SERVICE LETTER P-398

JULY 25, 1958

REAR SUSPENSION NOISE (1958 Thunderbird)

Fig. 1 - Rear Suspension Noise Correction

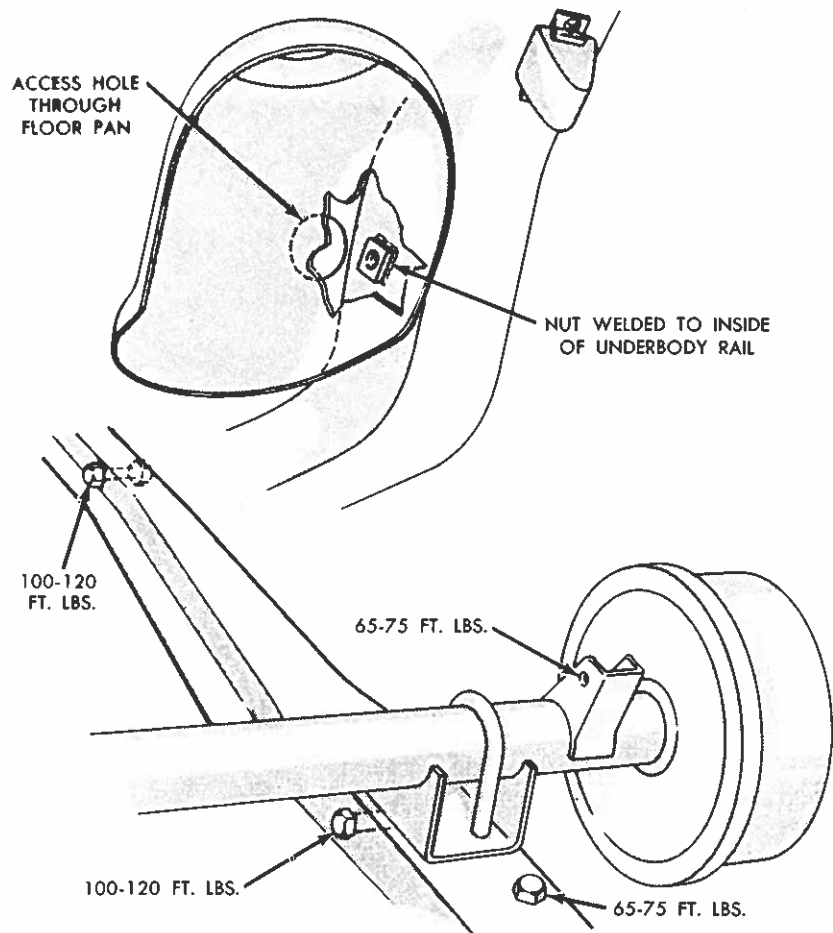
When rear suspension noise problems are encountered, the rear suspension members should be torqued to the specifications shown in Fig. 1. In those cases where the torquing operation does not eliminate the noise, and the noise is attributed to the upper suspension arm, the arm and attaching parts should be reworked as follows for the conditions which are found to exist.

In some cases, the spacer, installed in the frame at the rear axle upper suspension arm front attaching bolt location, will collapse when the bolt is torqued to 100-120 ft. lbs. When the spacer collapses, the outer frame side rail may also collapse slightly and allow the arms to loosen.

The new spacer should be installed as follows:

1. Raise the car, remove the rear wheels, and position a support jack under the rear axle.

2. Remove both upper suspension arms from the vehicle.

3. With a hand grinder, remove the flat washers from the outboard side of both

underbody side rails at the forward mounting bolt hole location.

4. Enlarge the forward mounting bolt hole in the outboard side of the underbody crossmembers to 1 inch diameter. Clean a 4 inch square area around the hole.

5. Position a 1 inch O.D. (minimum ID 13/16") tubing into the mounting bolt hole in the outboard side rail. Seat the tubing against the inner side of the inboard side rail and mark the length of the tubing flush with the outer surface of the outboard side rail.

6. Remove the tube, cut to the length

marked and chamfer the outer end of the tube to facilitate welding. (Fig. 2).

7. Position the spacer tube in the frame member and install the connecting link bolt finger tight to position the spacer in the side rail.

8. Apply wet asbestos packing to the fuel line to protect the fuel line during welding.

9. Tack weld the spacer to the side rail, remove the bolt, and weld the spacer circumference to the side rail. Grind the welds flush with the side rail.

10. Locate and drill a 23/32" hole in the center of each 3" x 3" piece of
